Product Change Notification

Change Notification #: 116037 - 01

Change Title: Intel® Power Supply FXX2130PCRPS,

Intel® Server Chassis H2204XXLRE, Intel® Server Chassis H2216XXLR2, Intel® Server Chassis H2224XXLR2, Intel® Server Chassis H2224XXLR3, Intel® Server Chassis H2312XXLR2, Intel® Server Chassis H2312XXLR3, PCN 116037-01, Label, PSU label change,

Image - Post-Change

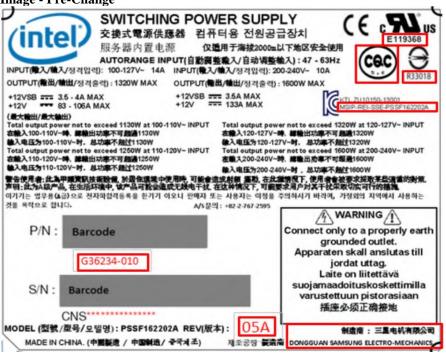
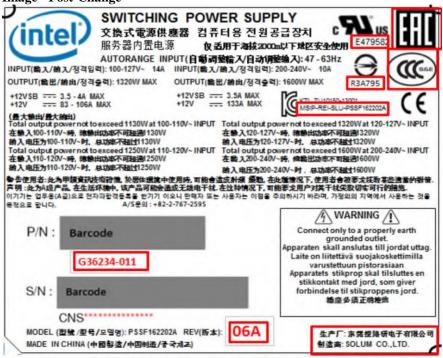
Intel is implementing the following changes on the Power Supply Unit Label for the Intel® Server Chassis and Intel® Power Supply listed in the products affected list

- 1. Manufacturer name changed from Samsung to SoluM
- 2. Safety logo changed from CQC to CCC
- 3. EAC logo added
- 4. UL code changed from E119368 to E479582
- 5. BSMI code changed from R33018 to R3A795
- KCC code changed from MSIP-REI-SSE-PSSF162202A to MSIP-REI-SLU-PSSF162202A
- 7. Intel dash number changed from G36234-010 to G36234-011
- 8. PSU Revision changed from 05A to 06A
